Letter I511

Subject: Revised DEIR Public Comments Regarding Traffic Impact Study, and DEIR Chapter 2.3 Traffic Impacts, Lilac Hills Ranch General Plan Amendment and Specific Plan PDS2012-3800-12-001(GPA), PDS2012-3810-12-001 (SP).

RE: Review of the Lilac Hills Ranch Development (LHR) in the unincorporated Valley Center area Traffic Impact Study (TIS) and Traffic/Transportation Sections of the DEIR for the project.

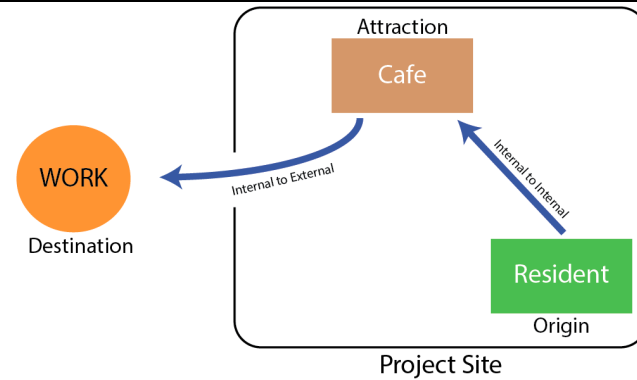
4. Roadway Capacity Assumptions under Existing Conditions:

In reference to Table 3.1 on Pages 28 through 30 and text on Pages 19 through 22:

The Level of Service calculations in the TIS are flawed and need to be corrected to reflect the correct project internal trip capture and capacity of each road.

The daily roadway capacity assumptions for existing conditions are based on the incorrect premise that the roadways are built to the full design standards of the applicable classification. In Table 3.1 the Level of Service (LOS) D threshold for 2-lane facilities without a two-way left turn lane is assumed to be either 8,700 or 10,900 with the exception of Valley Center Road and Miller Road (assumed to be 13,500 and 8,000, respectively). There is no indication in the TIS that, in fact, West Lilac Road Circle R Drive, Lilac Road, Old River Road, and other roadways, are not built with the appropriate design features, such as paved shoulder width, sight distance, design speed, curve radii, pavement thickness etc.

In order to determine the amount of capacity reduction to use in the analysis, several factors were considered. Most important, all of the roads considered for capacity reductions provide one lane in each direction and the number of lanes is the best indication of capacity. In terms of reduced shoulder width, since the shoulder is outside the traveled way, is rarely utilized by drivers, and the fact that the reduced shoulder width is present on only a small portion of the study roadways, a large capacity reduction would not occur. In terms of minimum curve radii, since the curves are only present on a small portion of the study roadways, a large capacity reduction would be inappropriate.

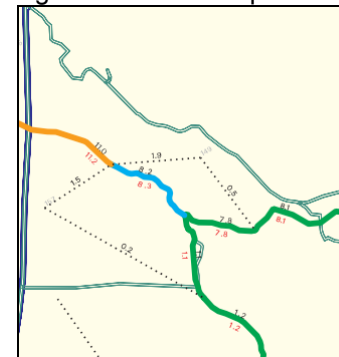
- Figure 9-5, just before Page 268 of the TIS, presents "Roadway Average Daily Traffic Volumes - Horizon Year Base Plus Project Conditions without

Road 3". In Figure 9-5 and in Table 9-9 on Page 269, the traffic volume forecast for W. Lilac Road between Old Highway 95 and Main Street is given as 13,370 vpd, resulting in LOS D. If the correct base of 5,160 vpd had been used instead of the incorrect base of 1,870 vpd, the total traffic volume forecast would have been 16,660 vpd, resulting in LOS E (instead of LOS D as Chen Ryan reports), indicating a traffic impact.

I511-24 Since the SANDAG Series 10 regional transportation model is no longer available, the rerouting of vehicular traffic under the "Without Road 3" scenarios was calculated by comparing the key study area roadway volumes from the following two Series 12 SANDAG regional models:

- Series 12 2050 with Road 3 with Project
- Series 12 2050 without Road 3 with Project

The effect of the Road 3 removal based on the above two models was applied to the Horizon Year Base traffic volumes.

Additionally, traffic from the Rancho Lilac project was also removed from the "without Road 3" scenarios since it would not be implemented because the property was purchased by SANDAG for mitigation and preserved within permanent open space. Please see TIS Section 9.0, General Plan Consistency Analysis, for additional information regarding the revised analysis.

ITE FIGURE 7.4 - Multi-Use Trip Generation Calculation

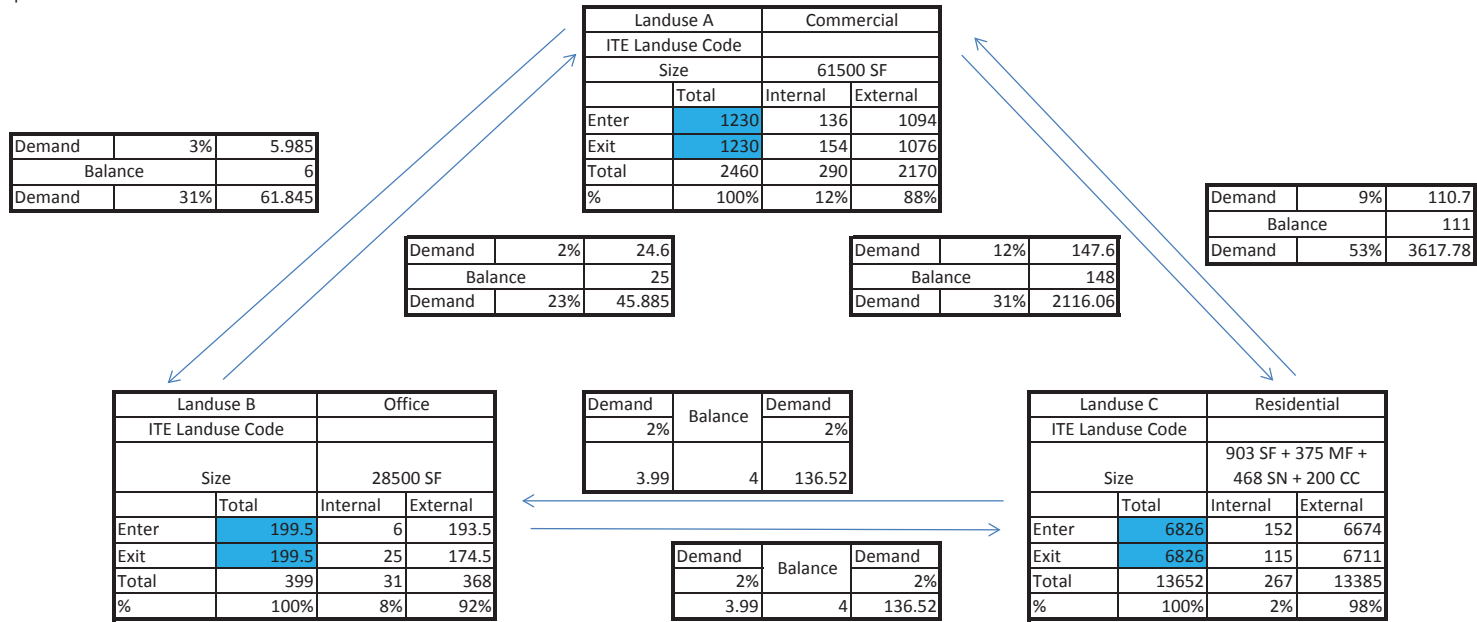
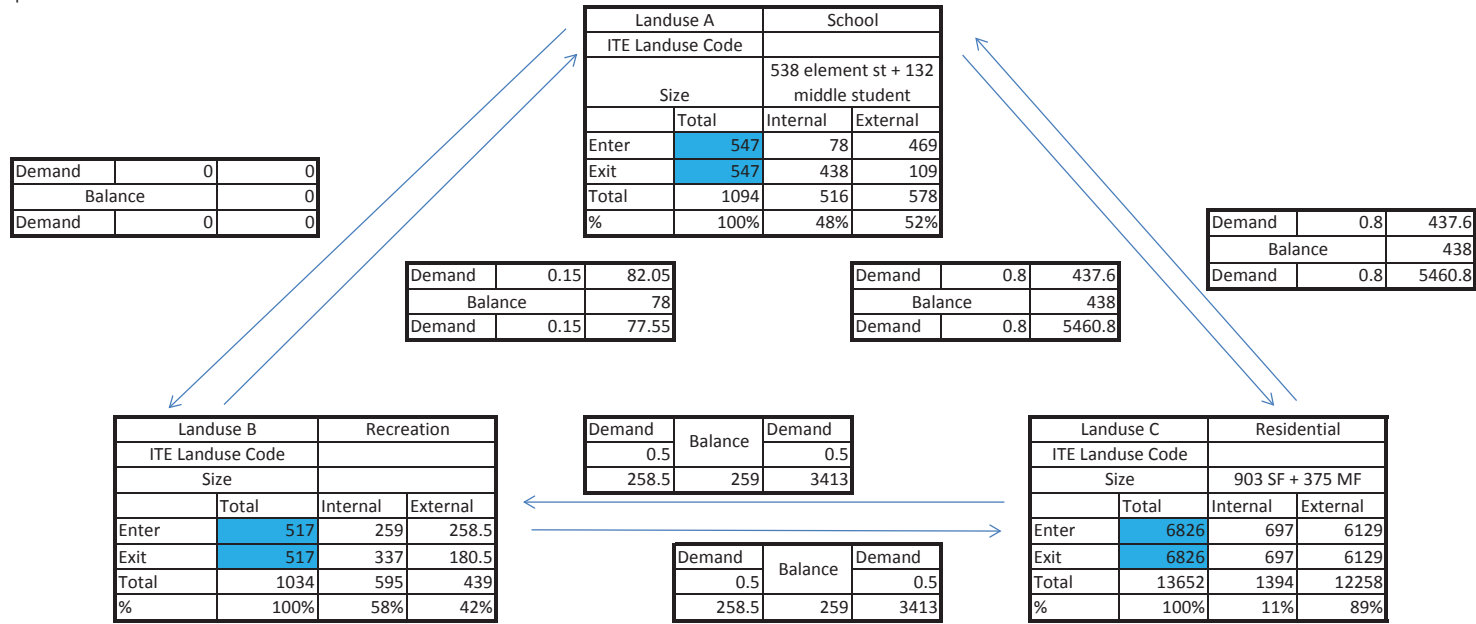
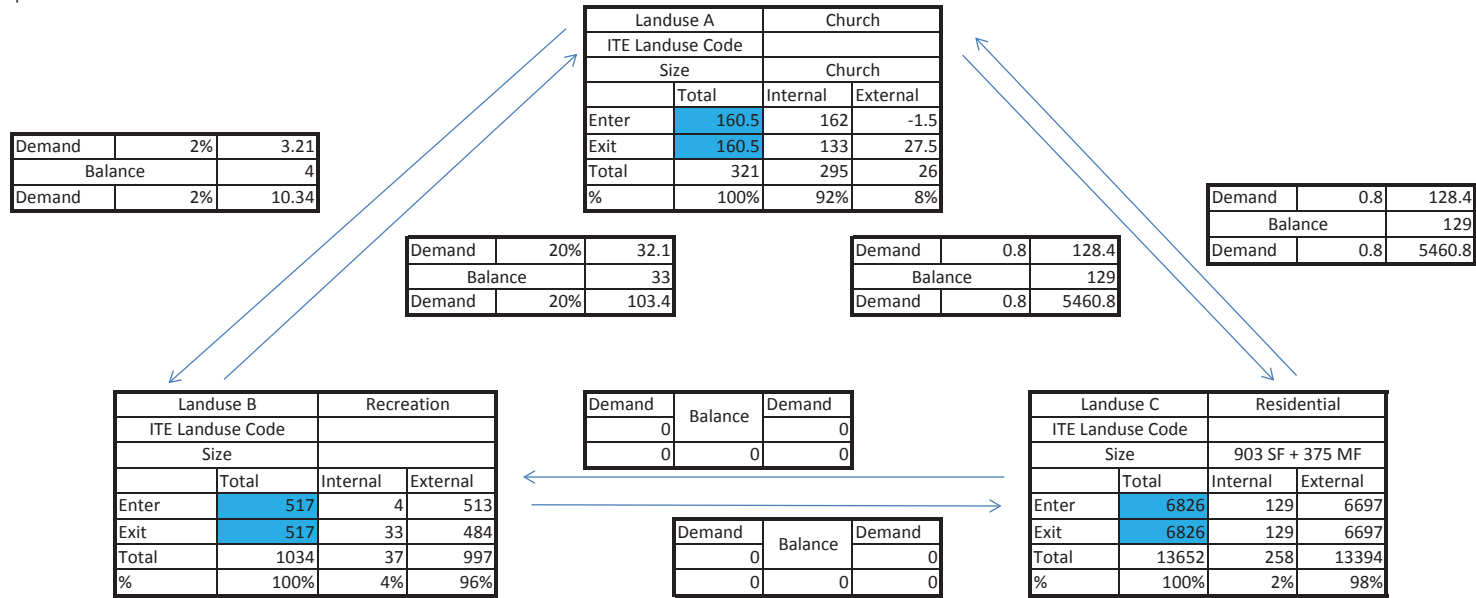
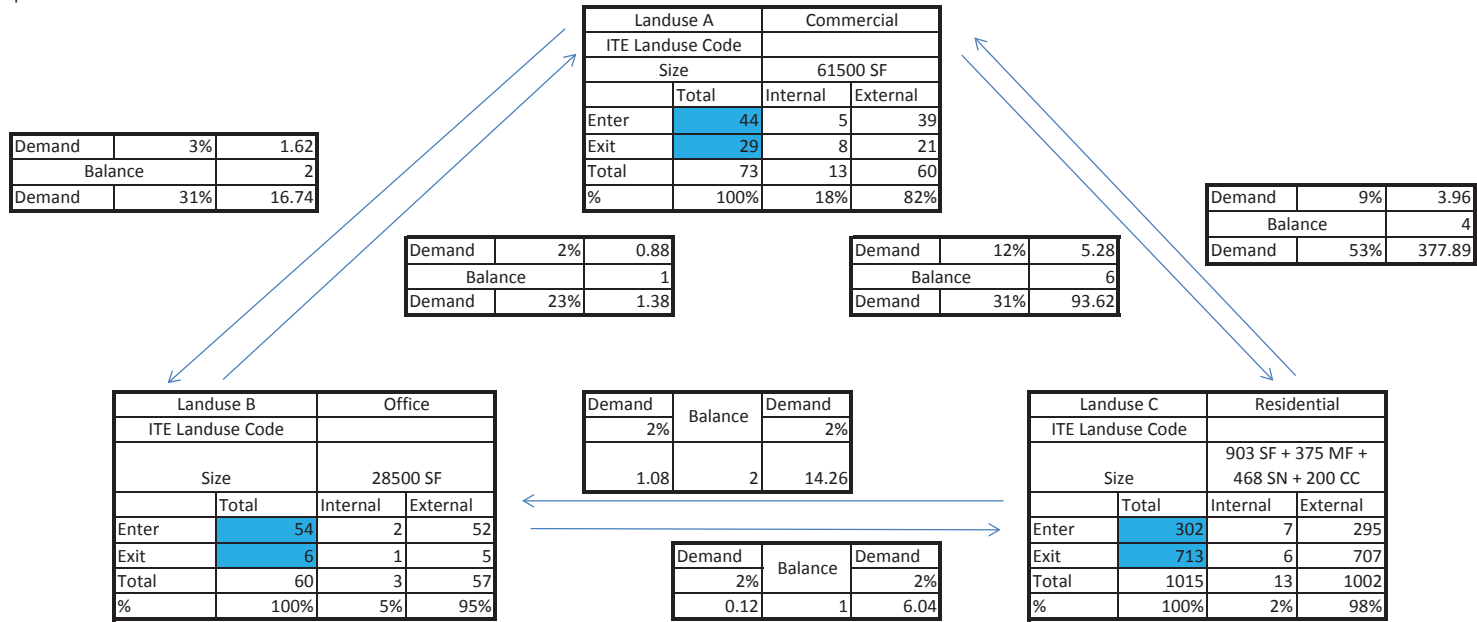
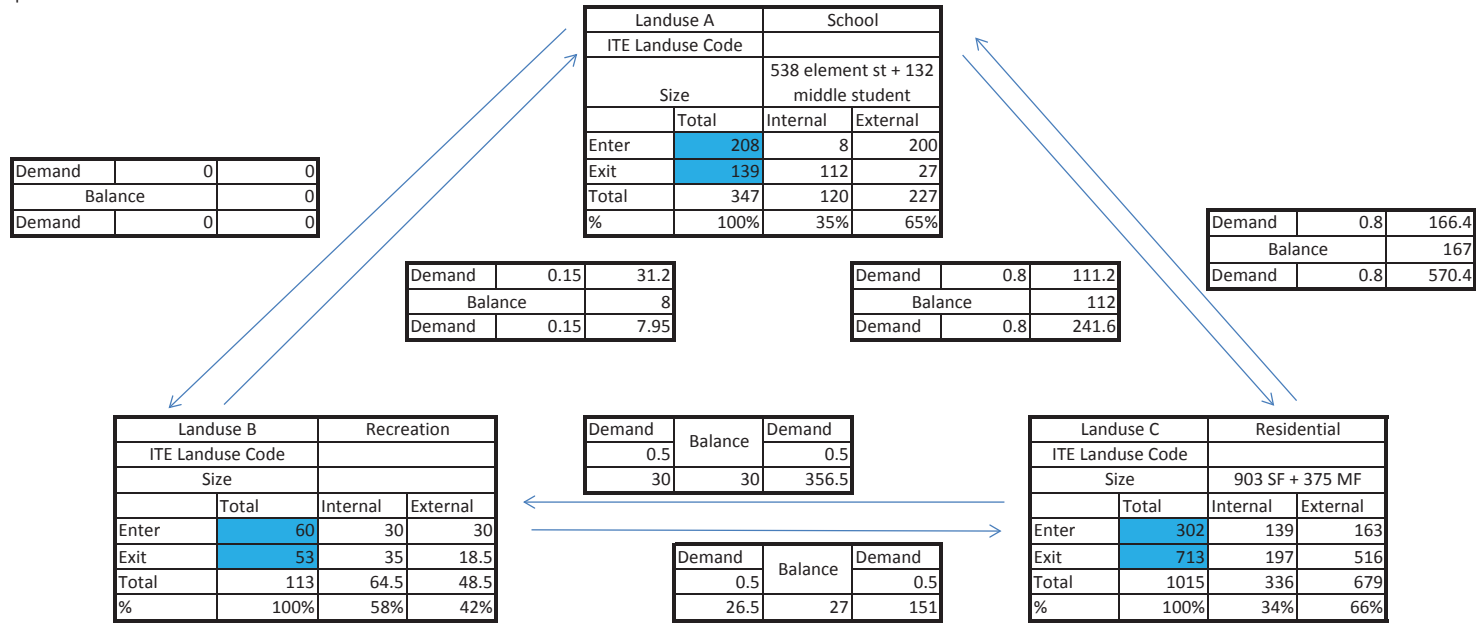
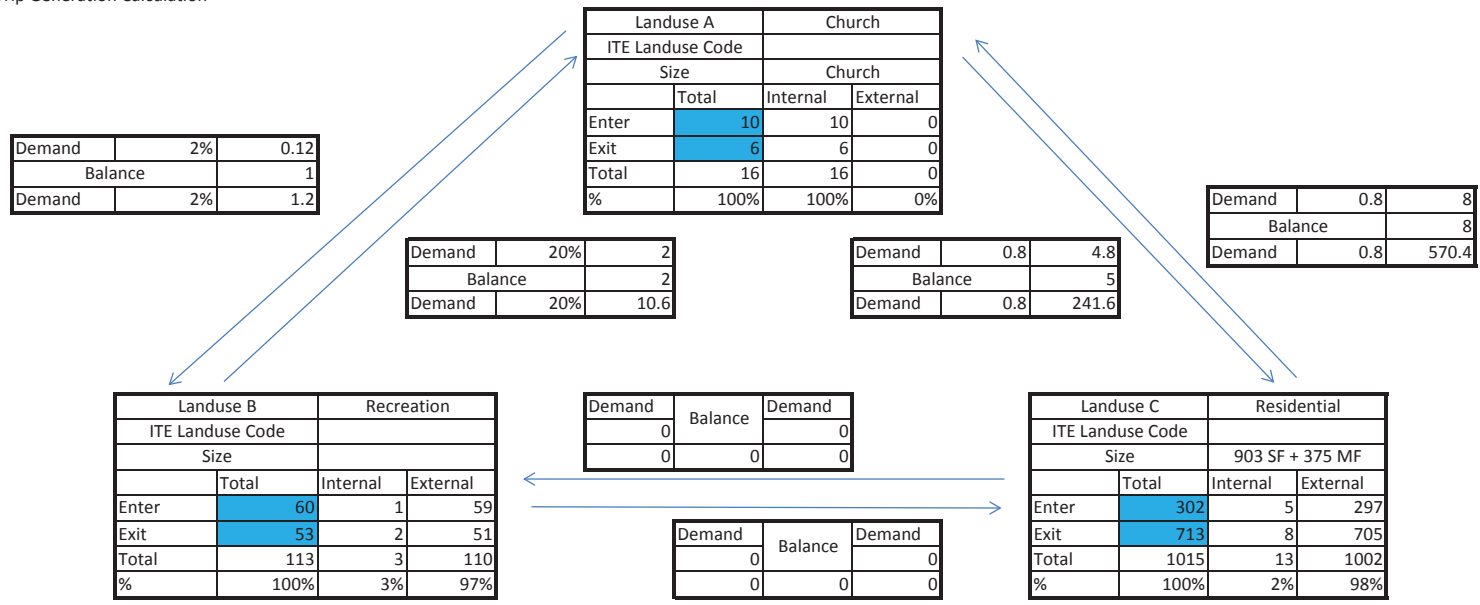
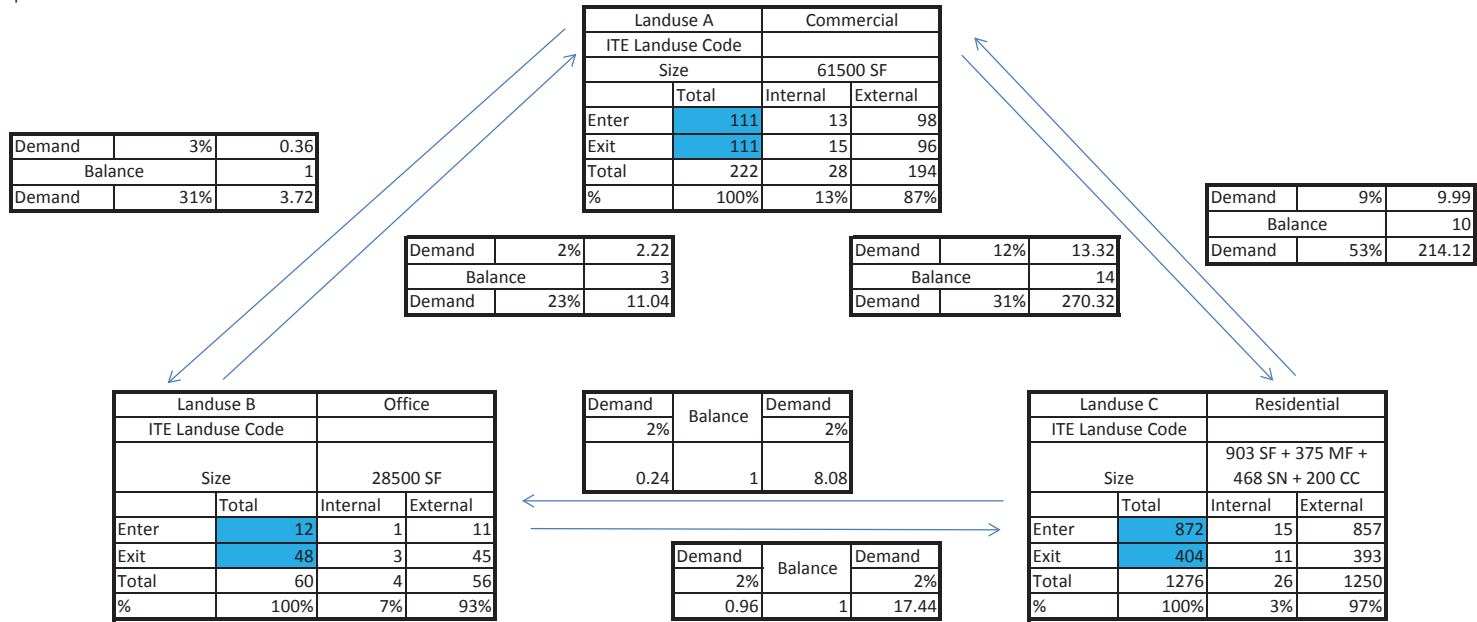
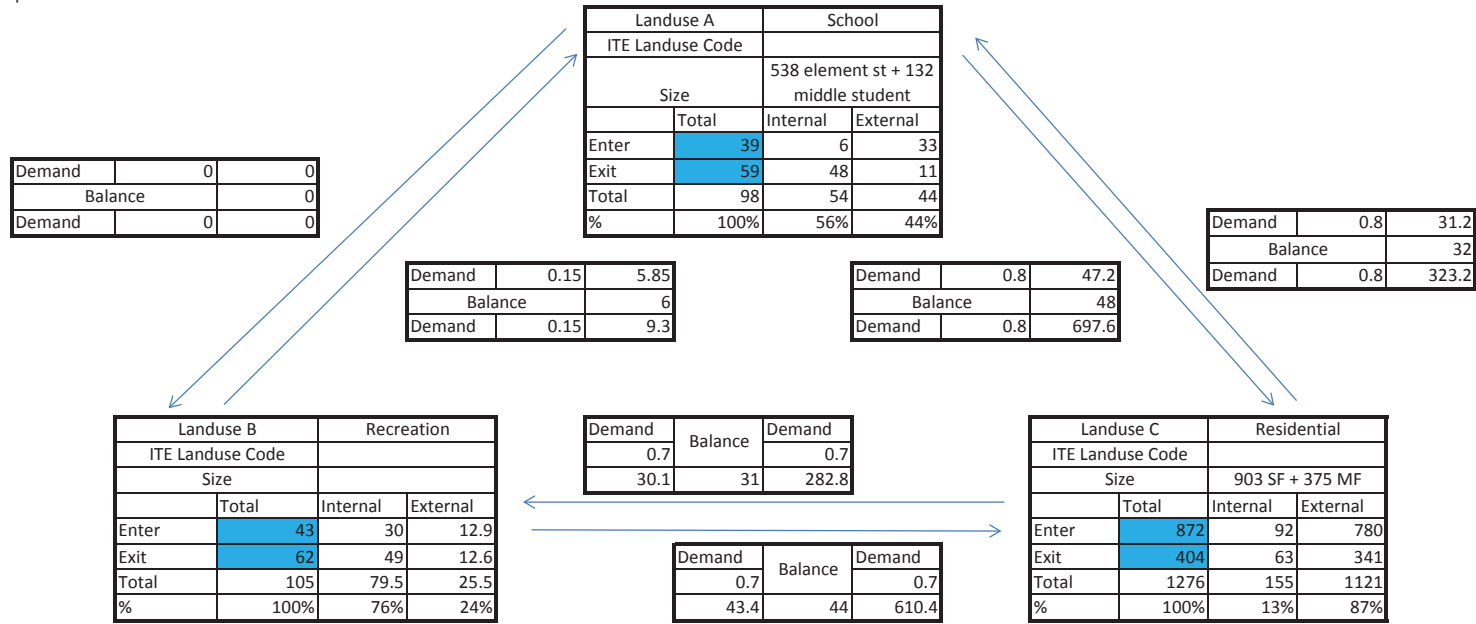
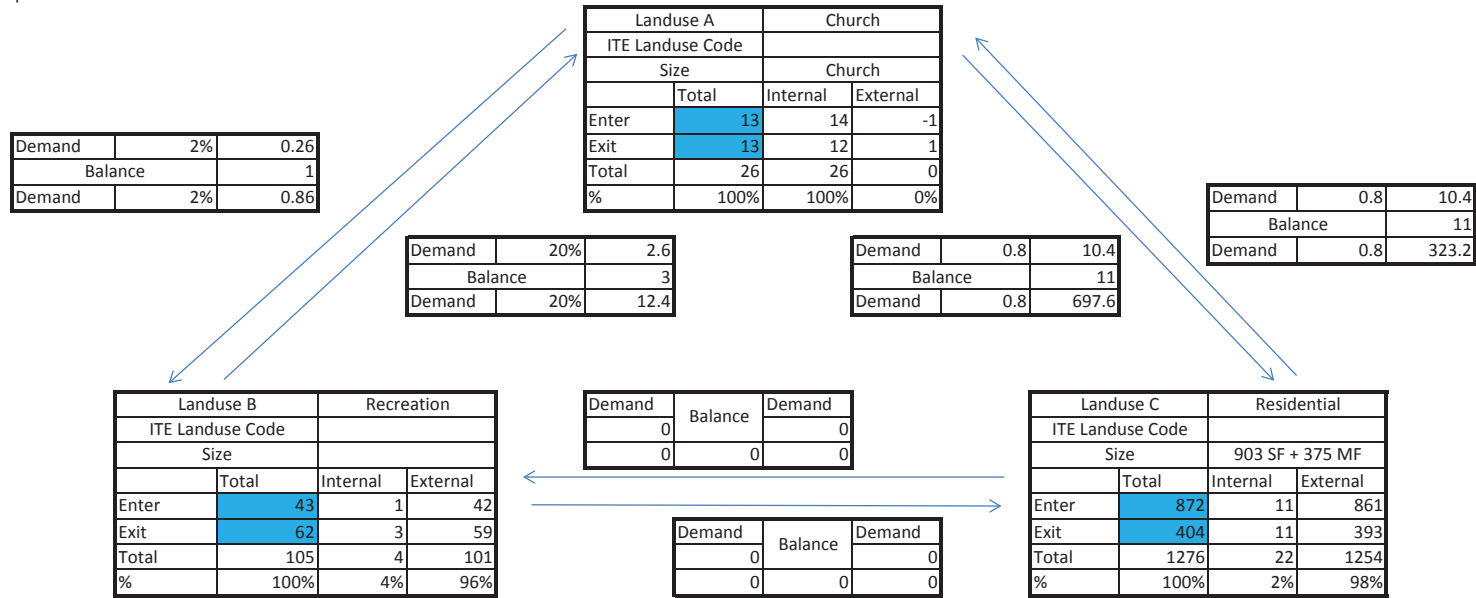
The revised estimates for internal trips are lower compared to the TIS, by 106 trips in the AM peak hour and 38 trips in the PM. Accordingly, external trips are underestimated in the TIS. Use of the correct peak hourly external trip numbers in the TIS, could have revealed additional impacts, beyond those identified in the TIS.

While it is true that the number of trip origins has to equal the number of trip destinations, the number of trip productions does not have to equal the number of trip attractions. The figure below displays an example of what is known as trip chaining or pass by trips, when a single trip reaches one or multiple additional attractions before its final destination. Trip chaining, particularly in multi-use developments, can result in an imbalance between the number of internal and external productions and attractions while maintaining a balance between the number of internal and external trip origins and destinations.

FIGURE 1
SANDAG SERIES 12 REGIONAL MODEL WITH CUMULATIVE PROJECTS
CUMULATIVE CONDITIONS

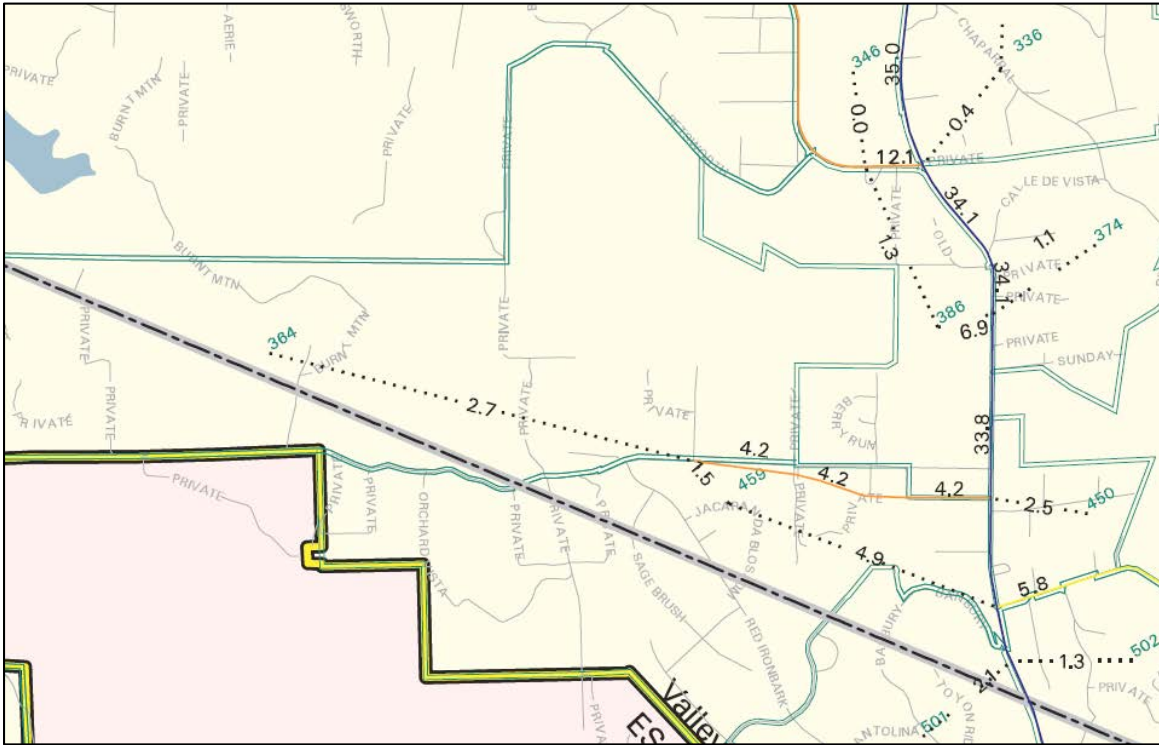
Review of Table 6.1 Cumulative Projects Page 191 Map Key #123 Orchard Run Major Subdivision (296 Lots) is identified as withdrawn. The Orchard Run Project is a valid project and needs to be included. The addition of this project will add significant volume traffic to West Lilac Road.

There was a text error in Table 6.1, revised Map Key #123 (page 240 of the TIS). In fact, the Orchard Run Project was included as part of the SANDAG Series 12 Year 2020 Regional Model. Please see Attachment D of this comment letter for documentation of the Orchard Run project, which was included as part of the cumulative model and was accounted for under the Existing + Cumulative + Project condition. As shown in Attachment D, the Orchard Run project was included in TAZ # 364 and TAZ 386. The increase of 325 Single Family dwelling units in both TAZ by the year 2020 is a very conservative estimate for the Orchard Run project. Hence, the cumulative traffic analysis is correct.

As shown above in Tables 3 and 4, the sum of SF units in both TAZ 364 and TAZ 386 is 406 SF units by the Year 2020, which is an increase of at least 325 SF units by the Year 2020. This increase in SF and decrease in Orchard or Vineyard Land Use resulted in additional traffic on the surrounding roadway network as shown in **Figure 1** below.
